Product Change Notification

Product Group: DR/Mon Dec 19, 2022/PCN-DR-00017-2022-REV-0

WSK1216 - Laser Ablation (0.0005 ohm only)

WSK1216 Laser Ablation (PCN-DR-00017-2022)

Figure 1 – Current Process

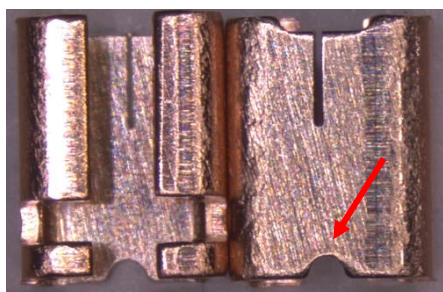
The current process uses a punched feature located at the bottom portion of Figure 1 (red arrow) for TCR adjustment and a laser cut to trim to value and tolerance. The revised process will use the same TCR adjustment punched feature and will revise the laser cut to a punched feature in Figure 2 (green arrow of Top side). Fine adjustments to resistance tolerance will be performed with a laser ablation process in Figure 2 (green arrow of Bottom side). This will be visually different by a darker color.

Figure 2 Laser Ablation

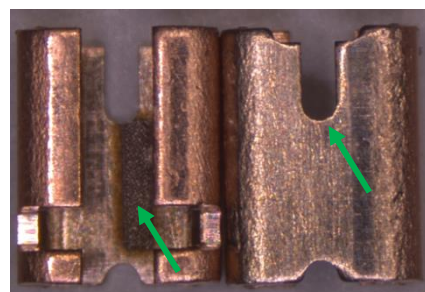
The larger punched coarse trim does not change the electrical performance, but will enable easier automated optical inspection to resolve the orientation of the part on the board with a larger and more visible feature.
